From: Robert Reineke <rreineke@ksinghengineering.com>
Sent: Wednesday, July 20, 2022 12:38 PM
To: Pfeiffer, Jane K - DNR
Subject: RE: CWC- West Block (02-41-587376) VMS Commissioning Info Request

PROJECT TITLE: SITE INVESTIGATION REPORT
3212 W. CENTER ST., 2727 N. 32ND ST., 2758 N. 33RD ST.
COMMUNITY WITHIN THE CORRIDOR - WEST BLOCK
MILWAUKEE, WI 53210
PROJECT NUMBER: 40443

SHEET TITLE
Sub-slab Depressurization
Location and Results

FIGURE 1

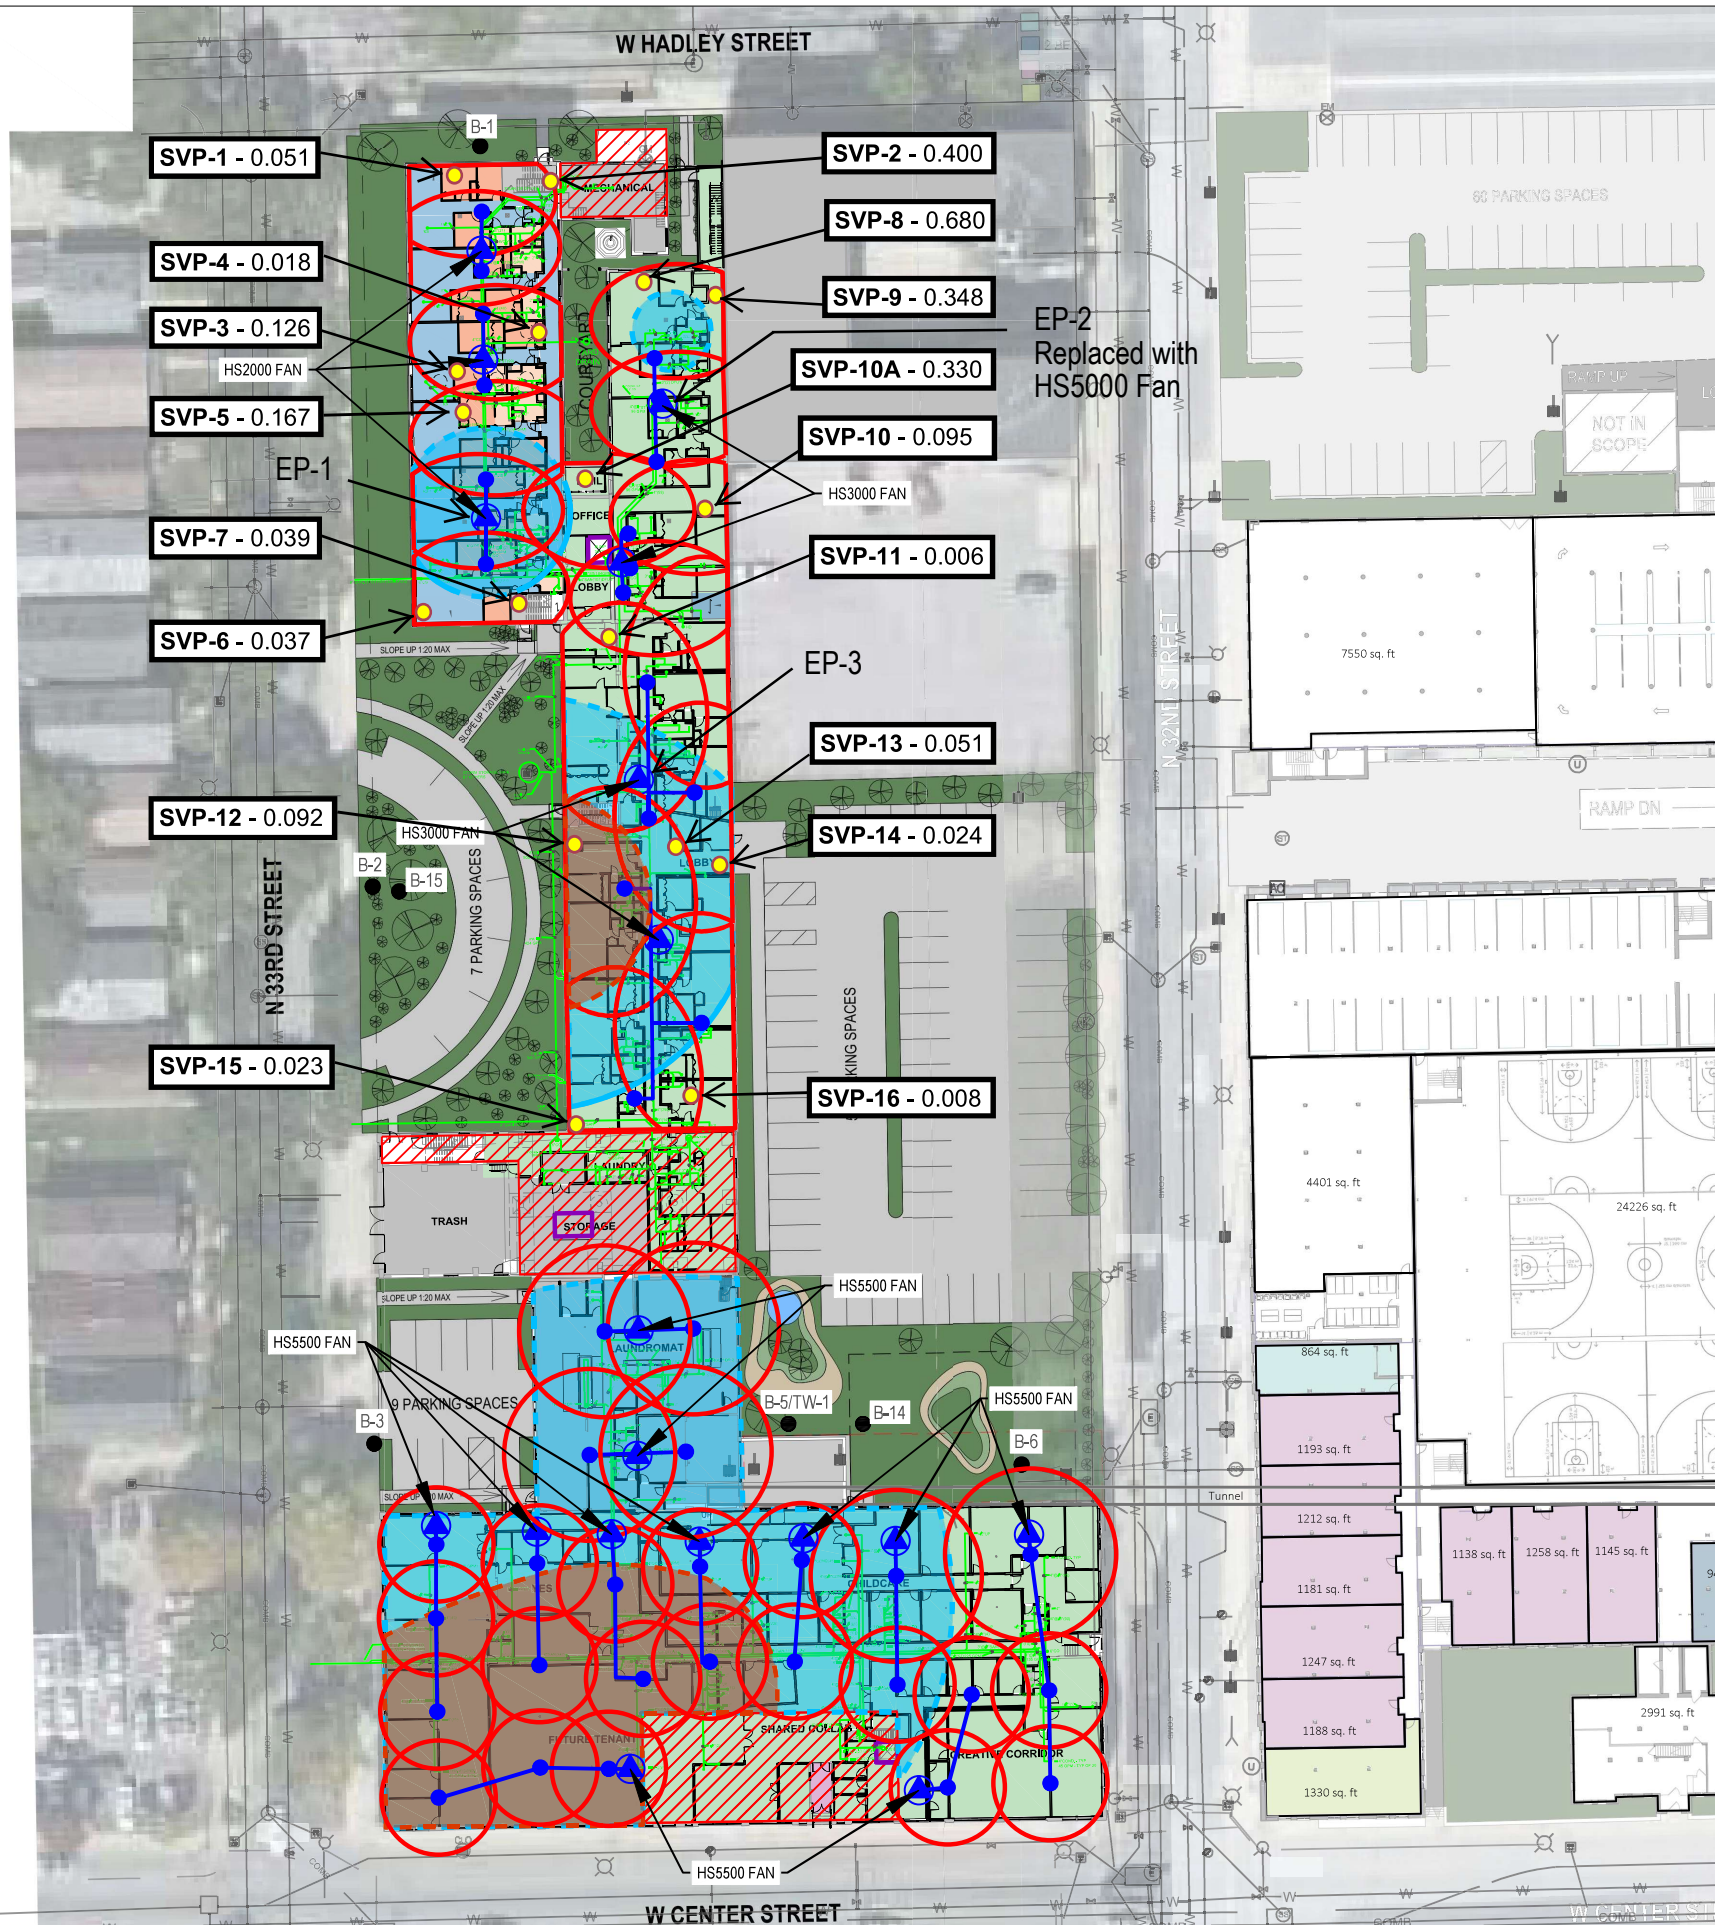
I think I found a map showing the fan locations – Please confirm that the “exterior fan locations” shown on the attached figure are correct and that these are the locations where the exhaust samples were collected.

Can you please provide me with an update on the first round of commissioning for Buildings 4 and 5 for the above-referenced site? Has the commissioning occurred yet and, if so, when will the results be submitted to the DNR? Additionally, please present a figure that displays the locations of all of the fans (i.e., the exhaust sample locations) on the rooftops of Buildings 6, 7, 8A, and 8B.

Those are the correct exhaust points.
